Docket Item # 4  
BAR CASE # 2010-0070

**ISSUE:** New Construction (Phase II, James Bland Redevelopment)

**APPLICANT:** Alexandria Redevelopment and Housing Authority (ARHA) and EYA, LLC

**LOCATION:** 801 Madison Street

Figure 13. Site lines of various units depicting visibility of rooftop solar collectors.

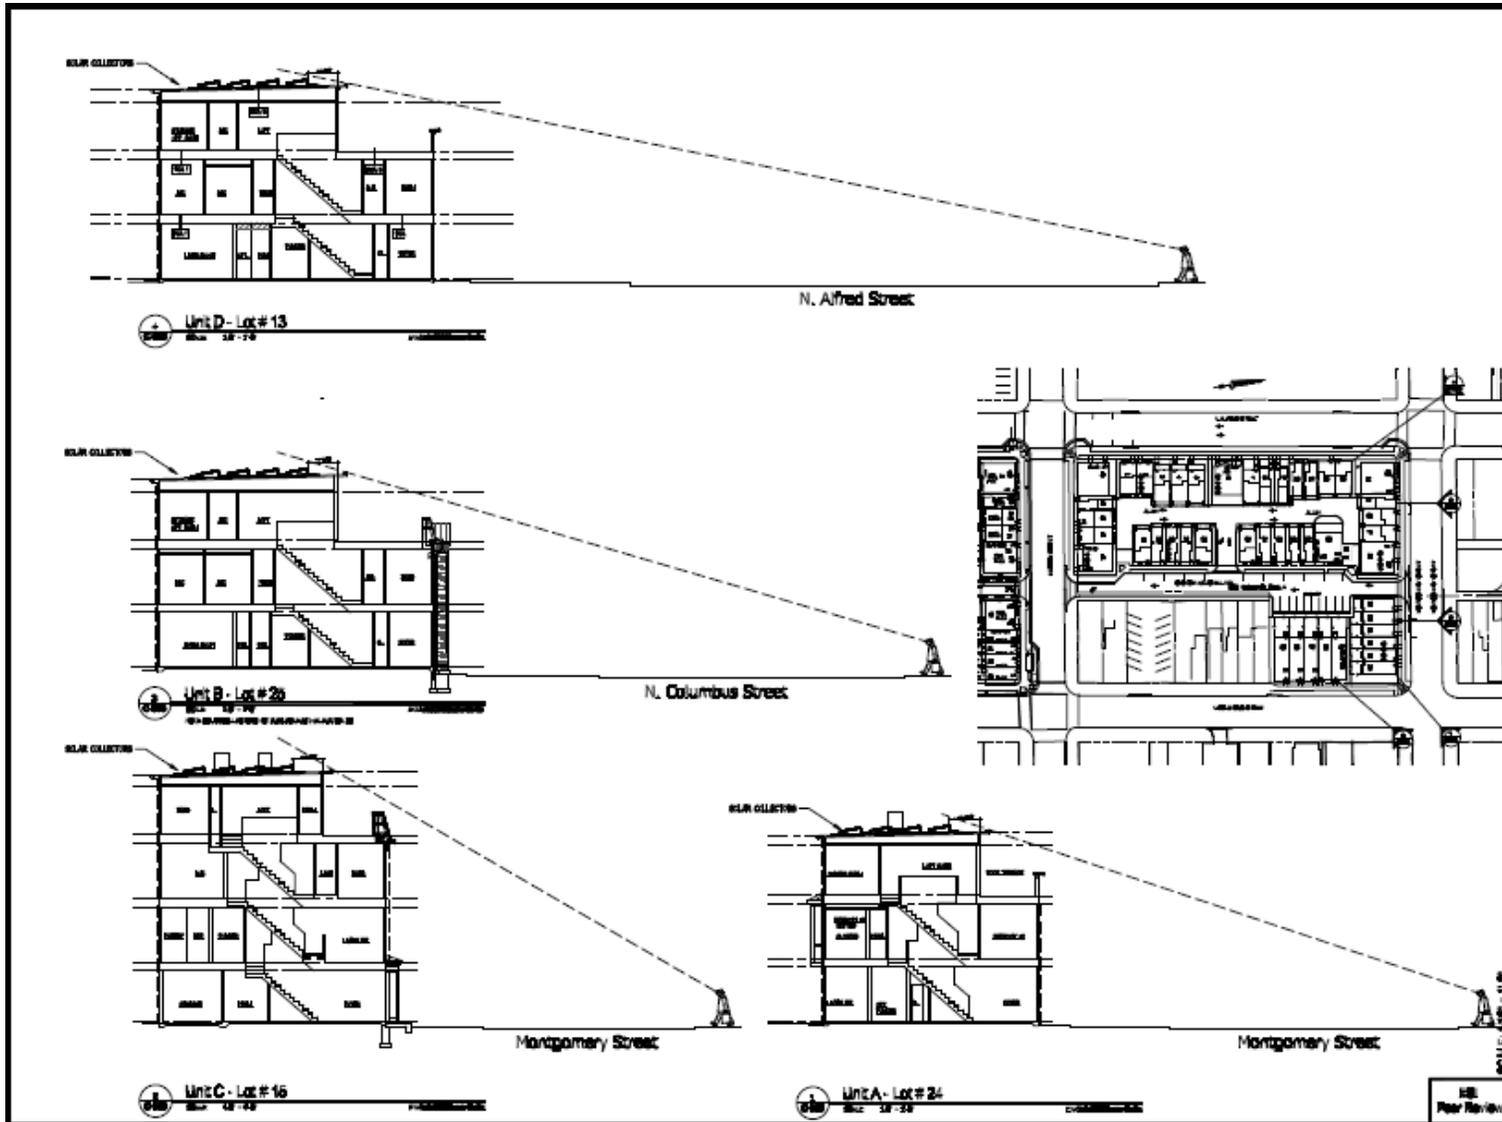
2. That the location of the solar collectors on the individual townhouses be approved by BAR Staff prior to their installation to insure that they are either not visible or are minimally visible;

Staff proposes to treat the approval of the solar collectors similar to the way rooftop HVAC condensers will be handled. The applicant proposes to install the necessary hardware for six solar panels to be located on the roofs of most unit types; however, installation of the units

themselves will be the responsibility of the future property owner. The solar panels specified by the applicant would measure roughly 6 feet by 5 ¼ feet. They would be placed at an angle, with the highest point 14 inches above the flat roof in order to maximize exposure to the sun. Instead of returning to the BAR for approval of the solar collectors on each unit, Staff recommends that the property owner, or the developer, work with BAR Staff to determine the most appropriate location for the solar collectors. It may be necessary to install mock-ups in the field so that Staff can determine the visibility of the solar collectors.

Figure 17: Detail of alley dwelling door with lintel and canopy.

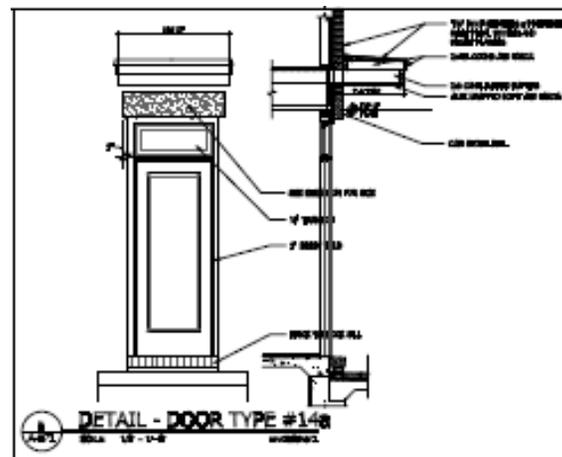
6. That the applicant work with Staff to simplify the wall area around entrance canopies on the alley dwelling units;
7. That the proposed split-face concrete block on the first floor of the alley dwellings be replaced with a smooth, ground concrete block to simulate stone;

Staff commends the applicant for making this change and looks forward to seeing the design of the alley units in Phase III. Staff has two relatively minor concerns relating to the redesign of the alley dwellings. First, there is no precedent for the use of split-face concrete block on Art Deco buildings. Rather, Staff recommends the use of smooth, polished concrete block which more closely reflects the polished granite base on some of the Art Deco buildings in the historic district, and the applicant has agreed. Staff’s other concern is the visually conflicting detailing surrounding the projecting canopies over the front doors, which include a transom, string course and lintel, along with the canopy. The applicant is in agreement that this area should be restudied and will work with Staff to simplify this portion of the façade.
